BEFORE THE UNITED STATES
ENVIRONMENTAL PROTECTION AGENCY

IN THE MATTER OF THE PROPOSED)	COMMENTS OF UNITED PARK
LISTING OF RICHARDSON FLAT)	CITY MINES COMPANY IN
TAILINGS, SUMMIT COUNTY, UTAH,)	OPPOSITION TO PROPOSED
ON THE NATIONAL PRIORITIES LIST)	RULE

MAP 1

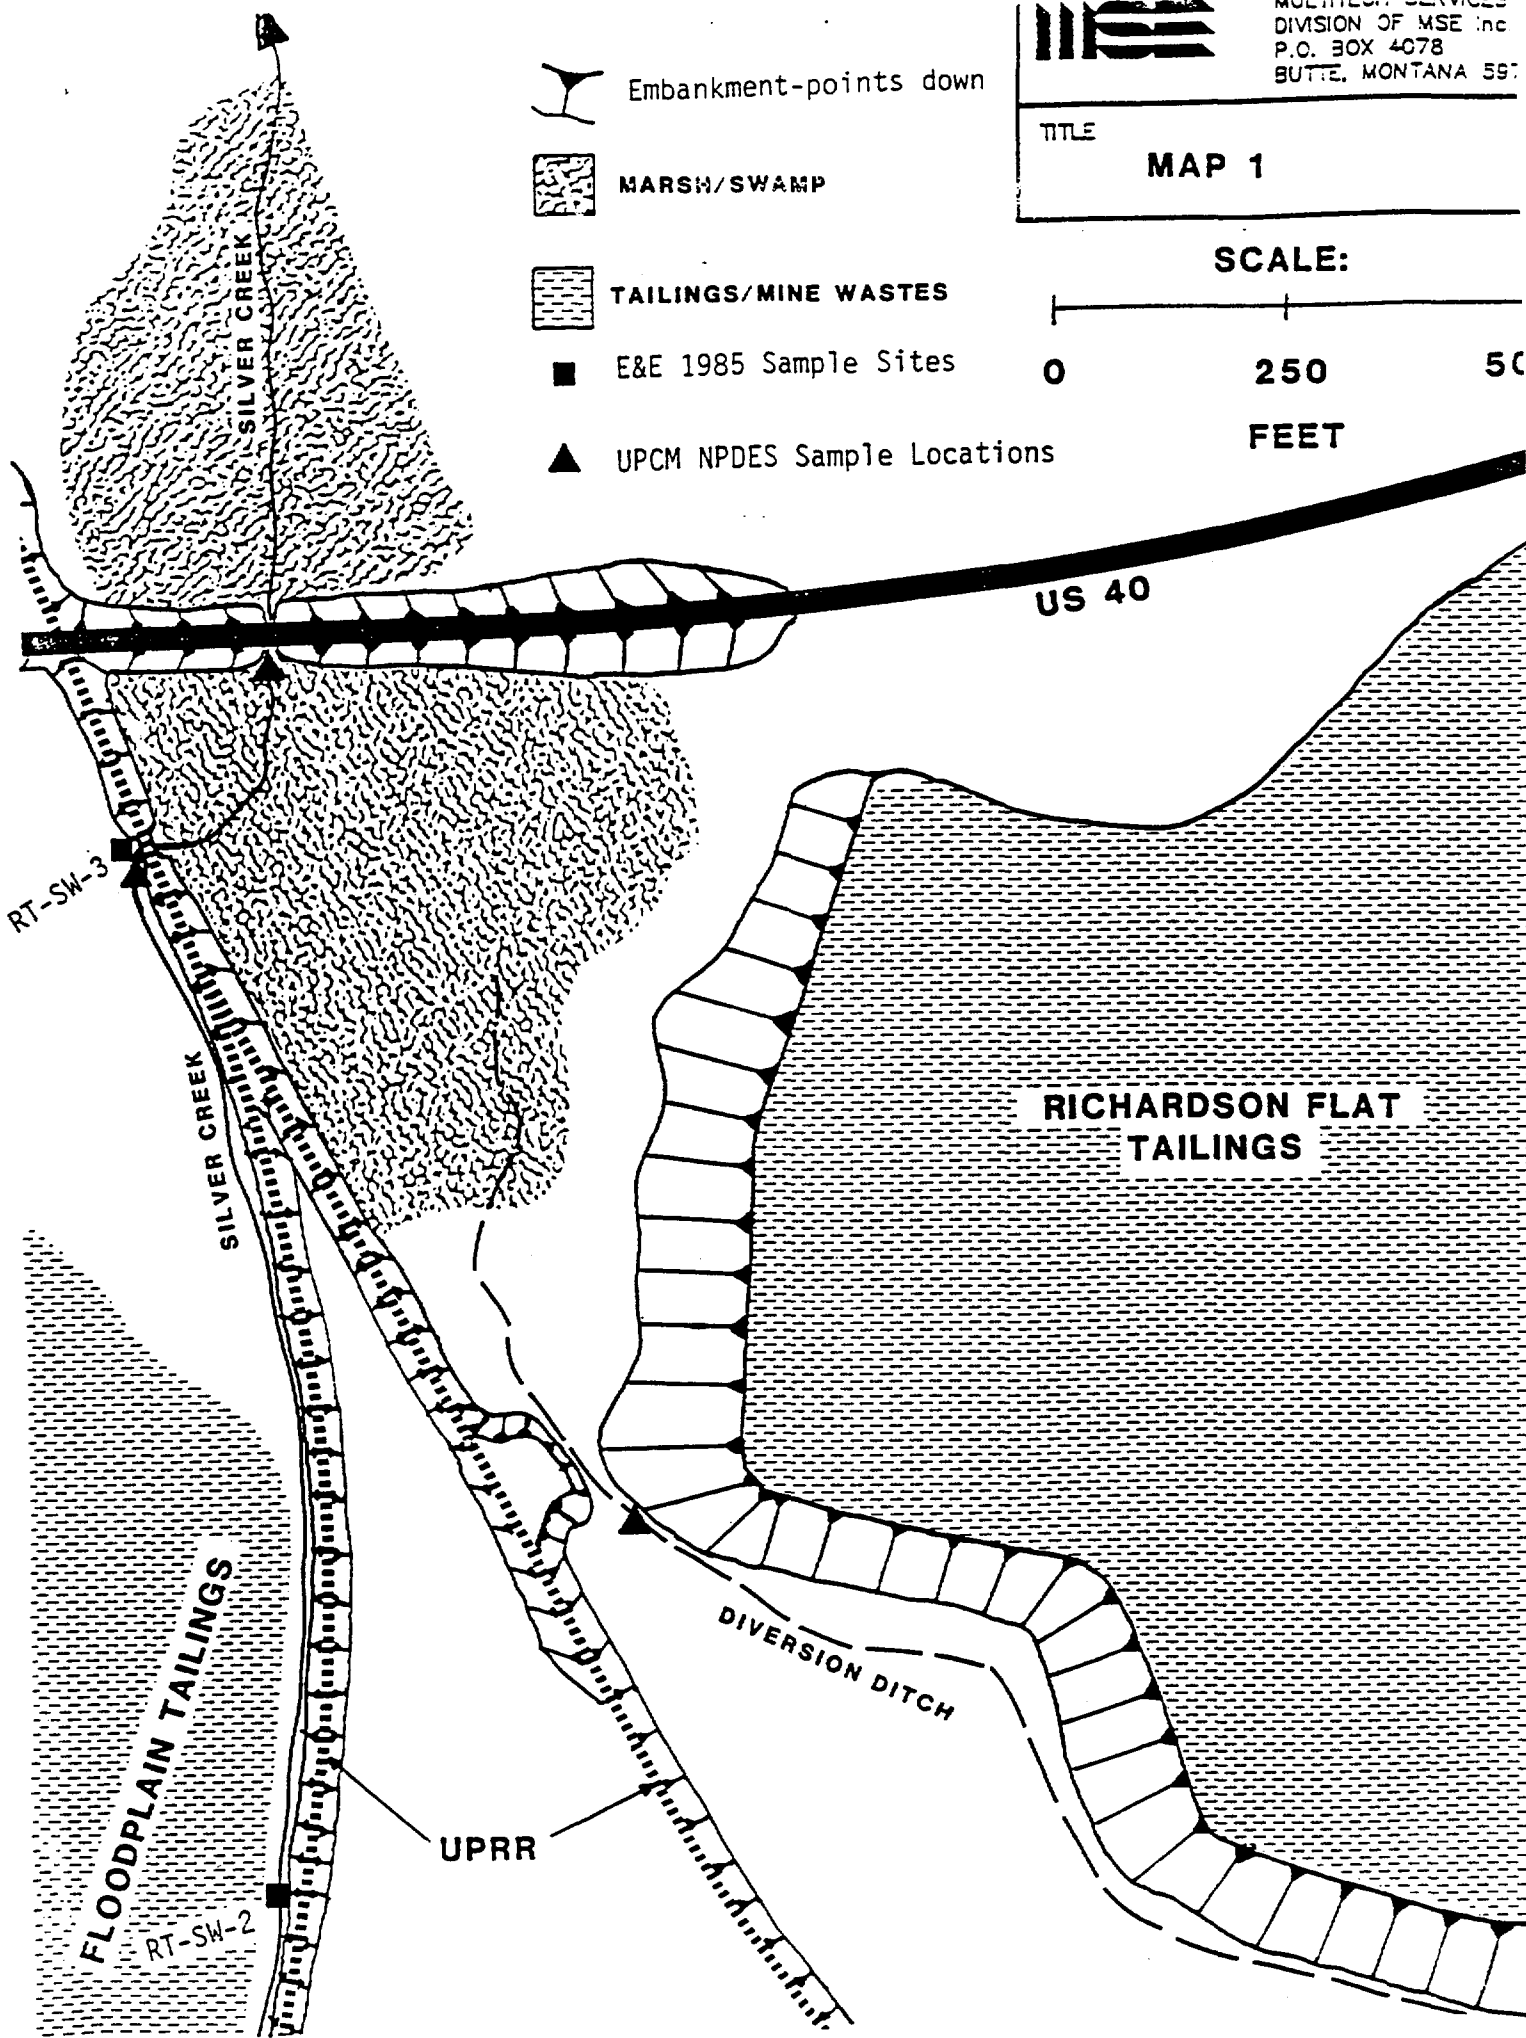
The score for Observed Release for the Surface Water Route should be 0 because no release is demonstrated by the data collected during June 1985 by EPA's contractor E&E. The sample listed as downgradient (RT-SW-3) was collected at the railroad

trestle at Keetley Junction, as per Figure 2 of both the Analytical Results Report and the Report of Sampling Activities, telephone communication of August 8, 1985 between Ms. Sue Kennedy of E&E and Kerry Gee, United Park, and as described on the Chain of Custody Record (attached hereto as Exhibit "A") given to United Park for its splits of samples received on June 20, 1985. This location is, in fact, upgradient from any hydrologic influence of the Richardson Flat tailings (see Map 1 attached hereto). The map (Figure 2) provided in E&E's Report of Sampling Activities and Analytic Results is grossly in error and Map 1, attached hereto, illustrates the correct hydrologic and spatial relationships in question.

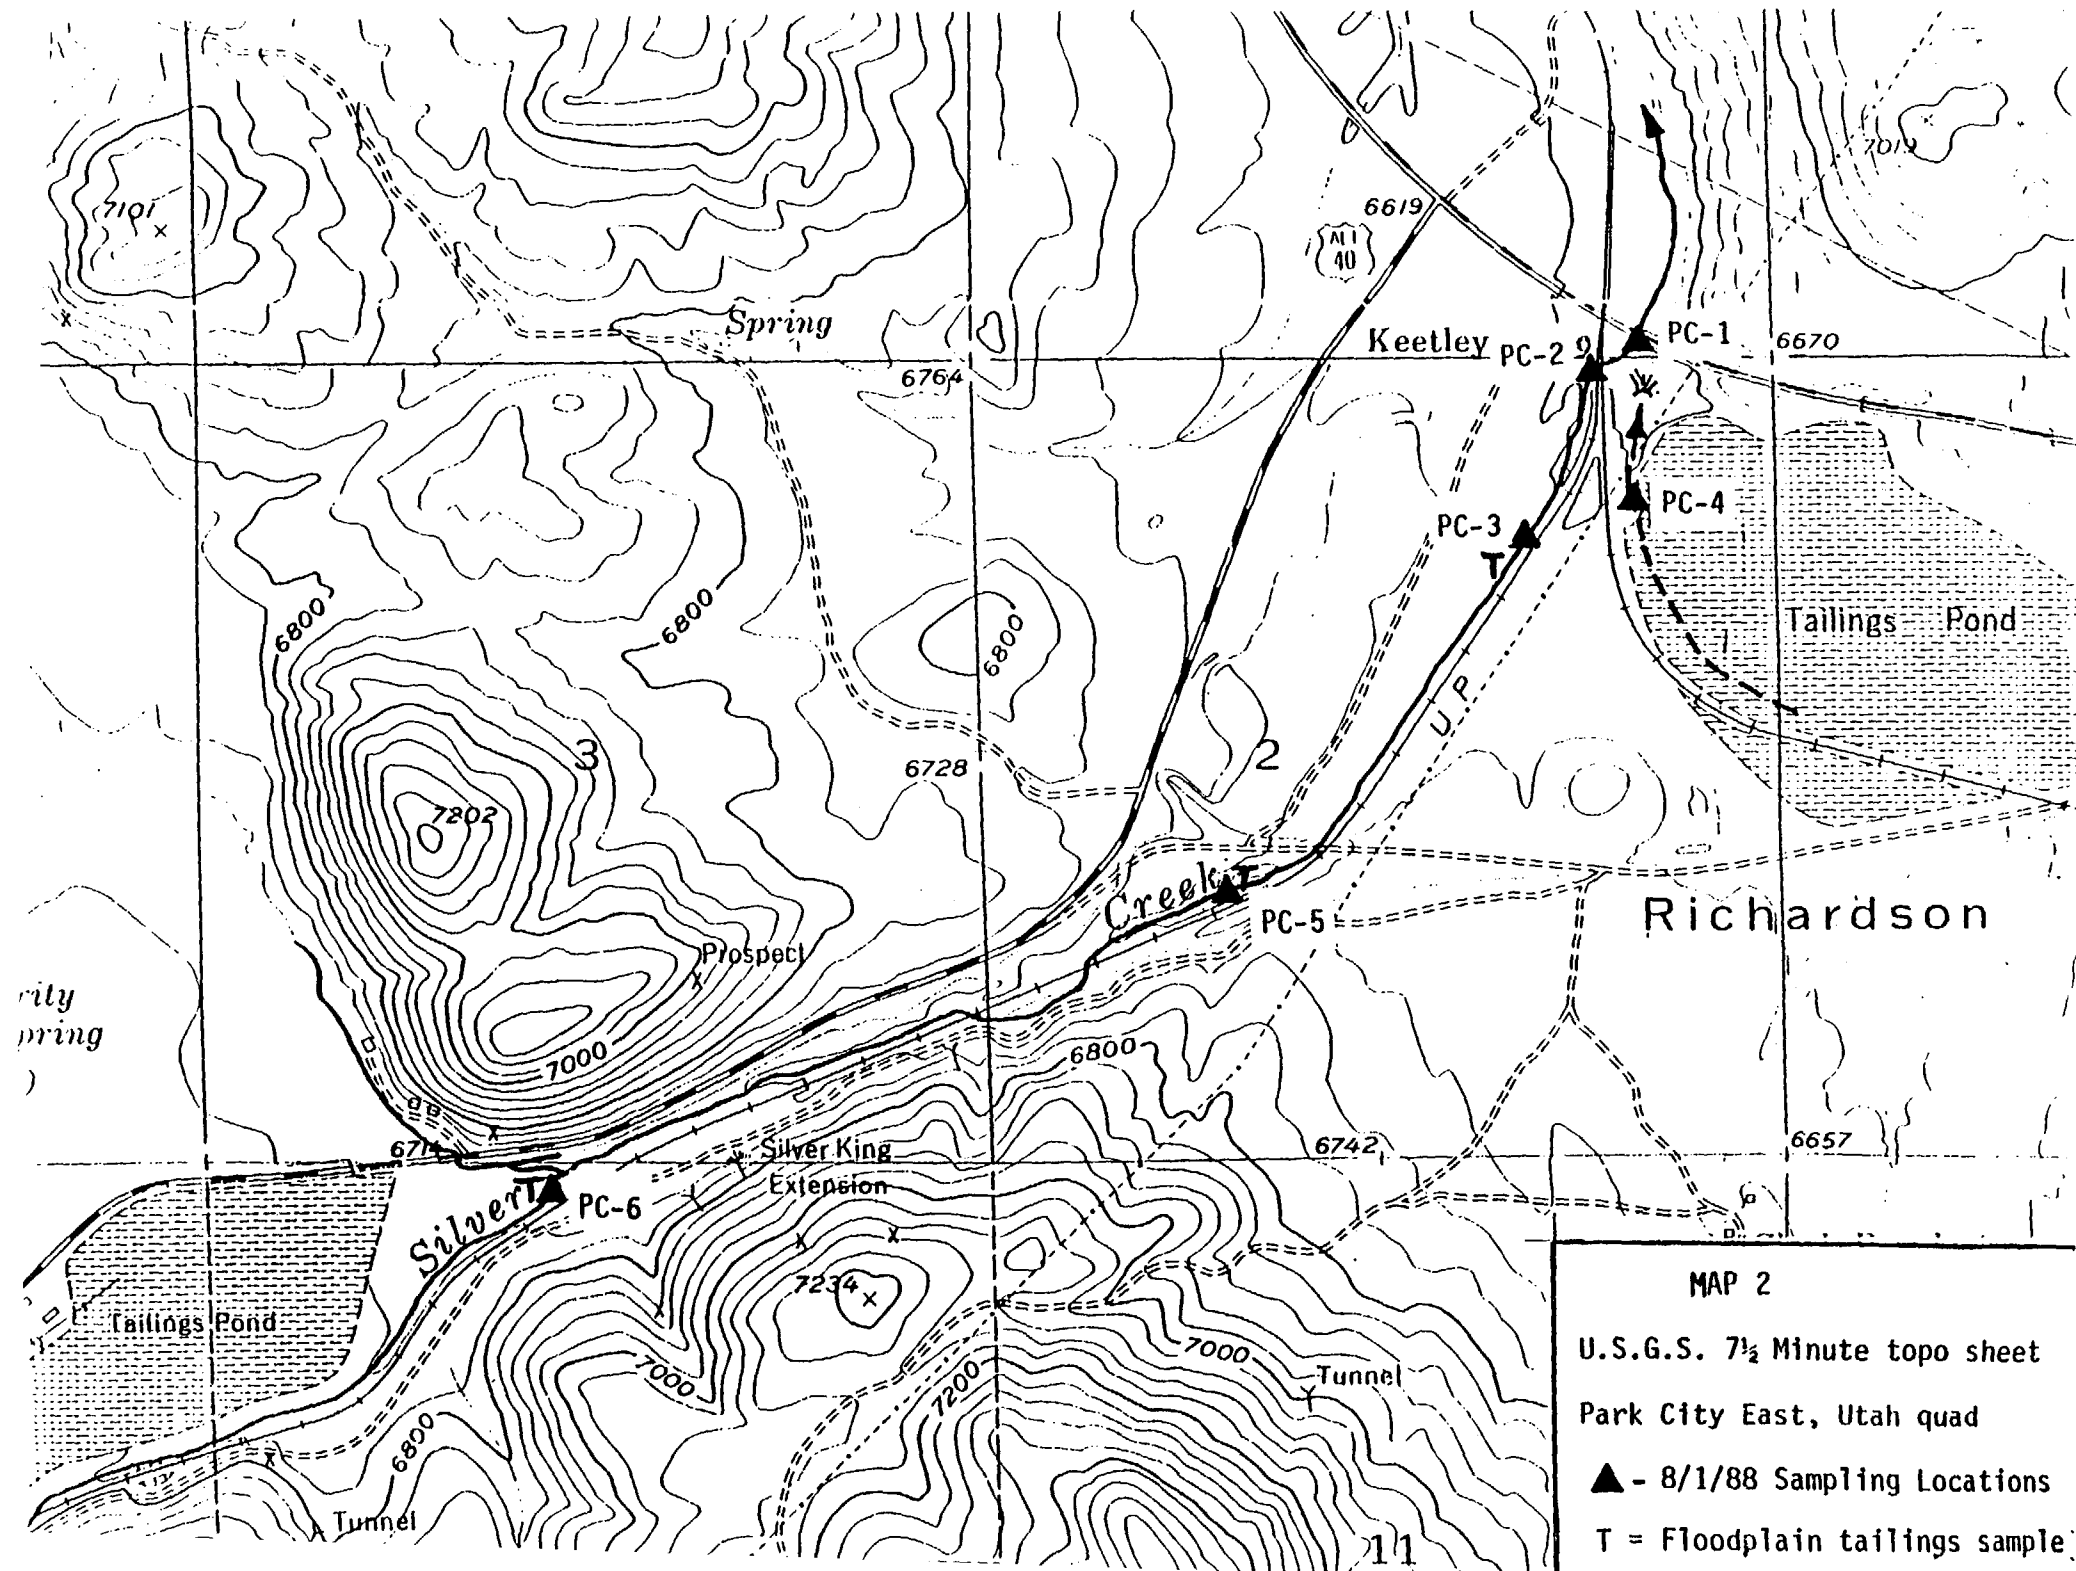
The difference found between RT-SW-1 and RT-SW-3 in E&E's sampling is most likely due to the inclusion of suspended solids in the samples. A review of aerial photos, a ground check and several samples (see Map 2 attached hereto and MSE's Table 5) confirm that portions of the Silver Creek flood plain are covered with stream deposited tailings emanating from Prospector Square. Consequently, the suspended sediment load within the stream can contain an abundance of tailings materials. Total metals

analyses reflect these suspended tailings in the stream water and show a great deal of variance depending on sampling methodology, sampling locations, and seasonal variables (spring runoff, storms, dry periods, or irrigation withdrawals). These factors can easily account for the high metal concentrations found in RT-SW-3 by E&E in 1985. Filtered water samples are specific to dissolved metals and eliminate the influence of suspended particulate material. Thus, filtered samples provide a more accurate measure of metal content in the water available for uptake by plants, humans, and livestock. Table 2 in MSE's Report compares total and dissolved metal concentrations found by MSE in Silver Creek on August 1, 1988 (locations correspond to those on Map 2). These data illustrate the significant differences which exist between dissolved and total metal values at the same sampling location, with total metal concentrations as much as 18 times higher than dissolved metals. These data support the hypothesis that metal levels observed by E&E in 1985 are primarily due to suspended sediments, probably derived from floodplain and streambank tailings deposits along Silver Creek.

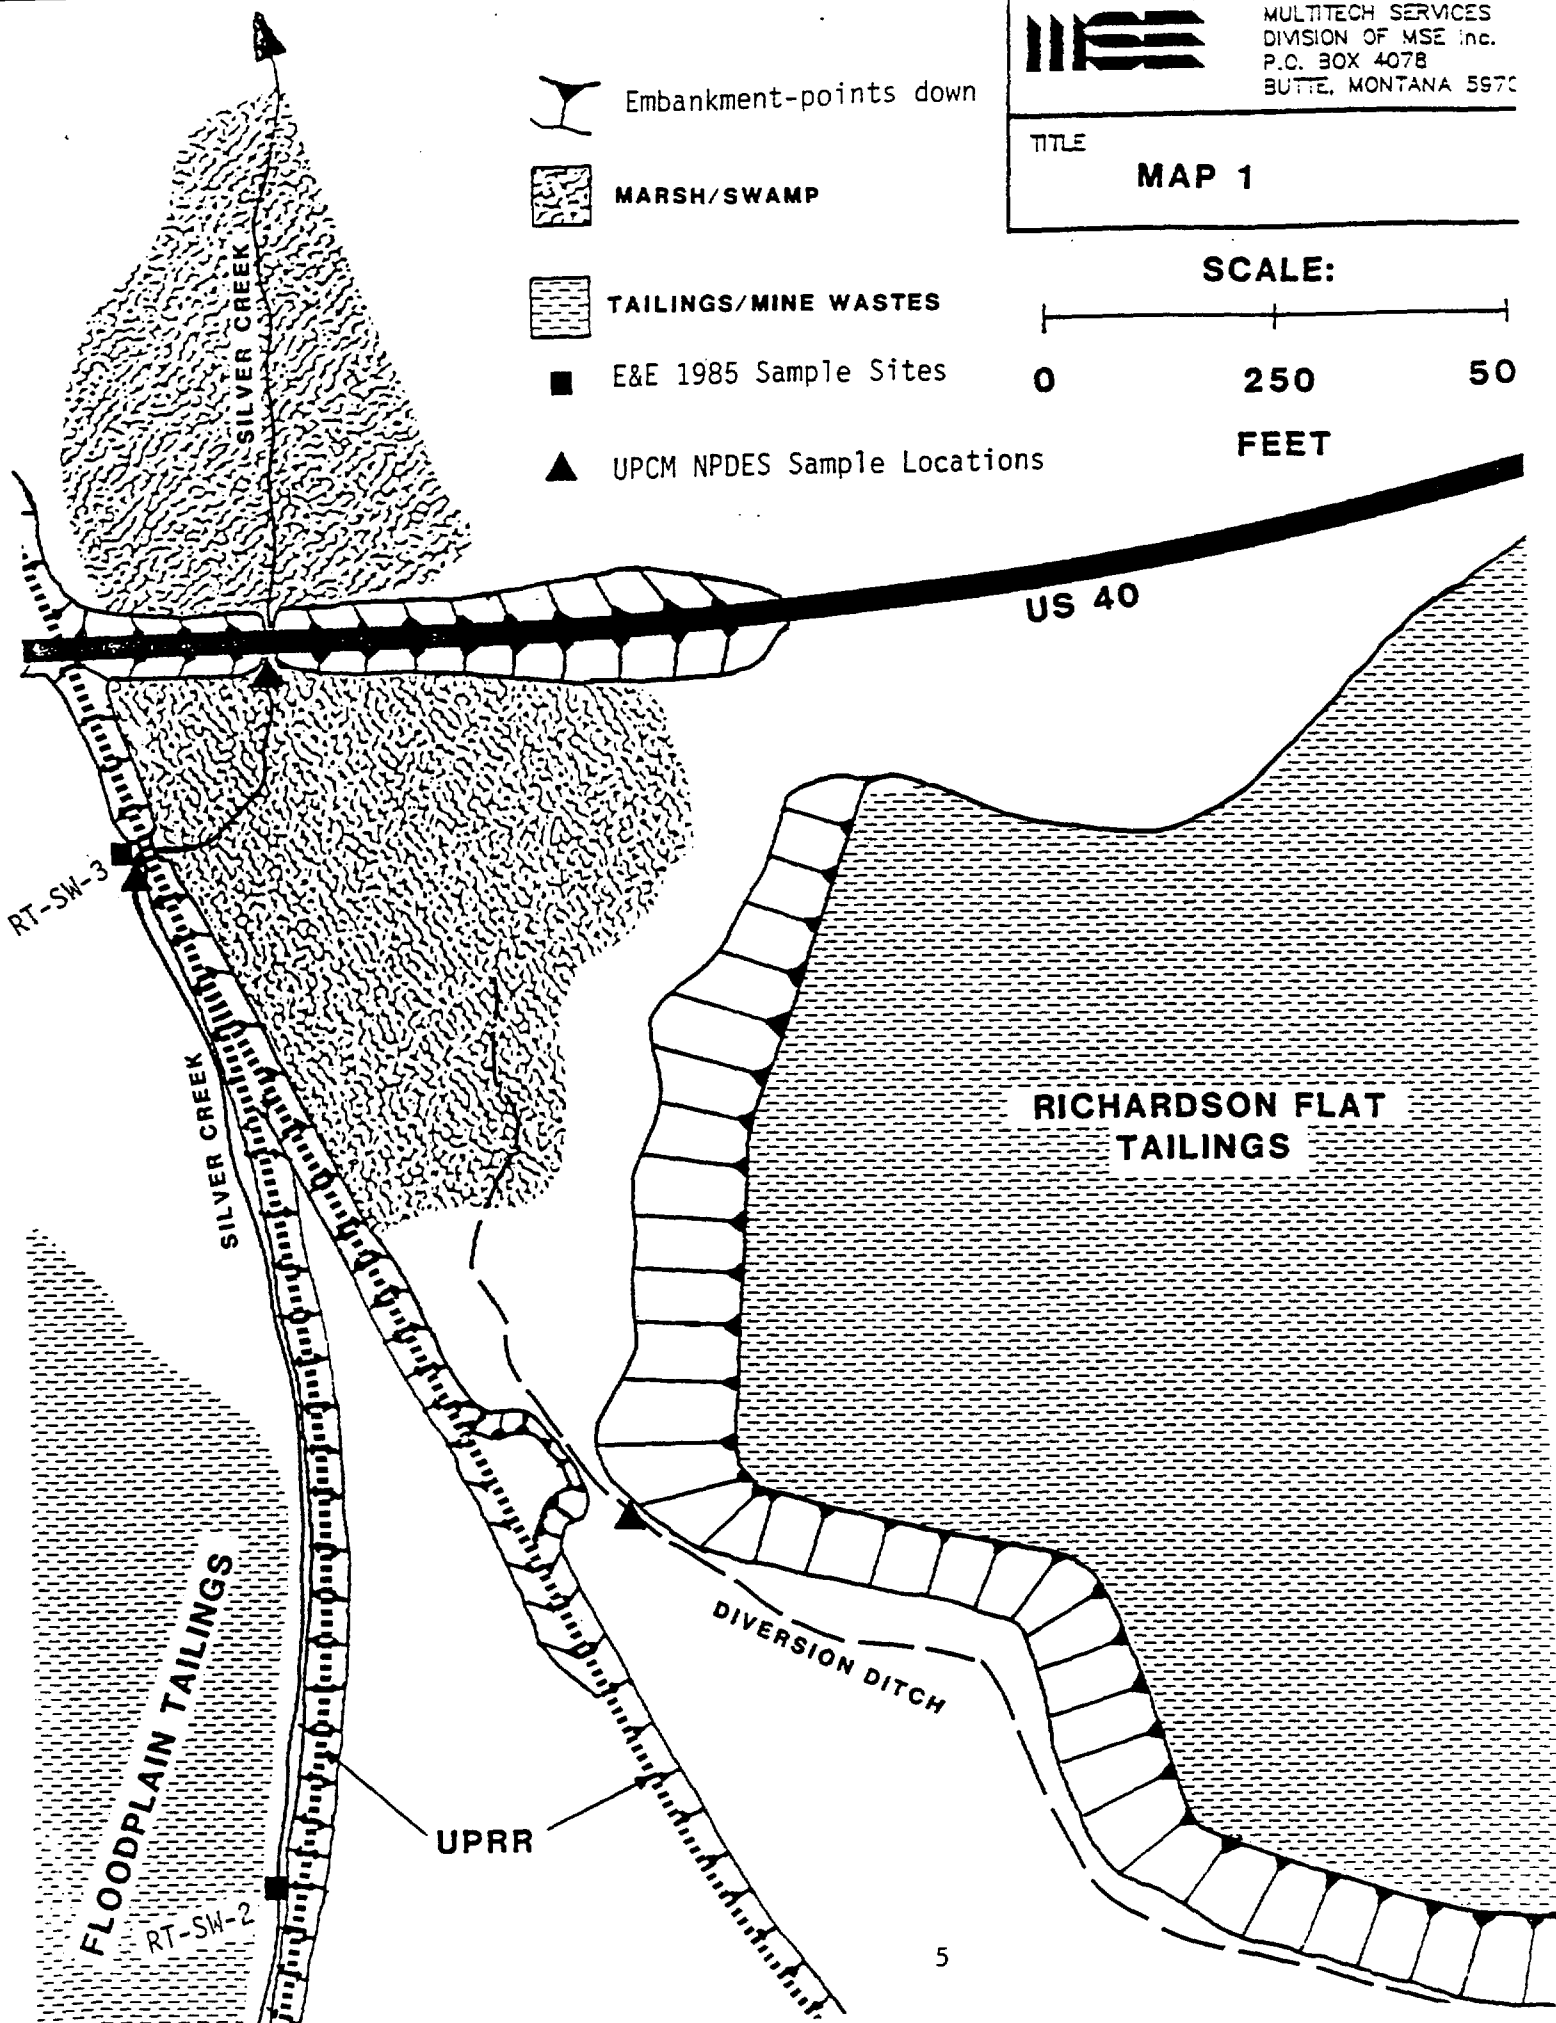
This score should be 0 since no release has been demonstrated by the data collected during July 1985 by Ecology & Environment (E&E). The sample listed as downgradient (RT-SV-3) was collected at the railroad trestle, per the location map in the Sampling Activities Report, the chain-of-custody forms, and communication with Ms. Sue Kennedy of E&E. This location is, in fact, upgradient from any hydrologic influence of the Richardson Flat tailings (see Map 1). The map provided in E&E's report is grossly in error, and Map 1 illustrates the correct hydrologic and spatial relationships in question. The "downgradient" sample site at the railroad trestle corresponds to United Park City Mines' upgradient NPDES sampling location. As shown on Map 1, any influence from Richardson Flat tailings would enter Silver Creek between the railroad trestle and the culvert under US 40. Any influences from either the diversion ditch through the tailings or seepage beneath the tailings dam would be confined to the marsh between the railroad grade and the highway embankment. The correct sampling locations to measure possible releases from the Richardson Flat tailings correspond to those regularly sampled for NPDES requirements, that is: upstream sample at the railroad trestle and downstream sample at the culvert under US-40. These locations have been regularly sampled since 1977 and analyzed for Total Pb, Mn and Hg. NPDES data are summarized in Table 1, lead is the only element presented since Hg was almost always below detection and Mn is not listed as an element of concern.
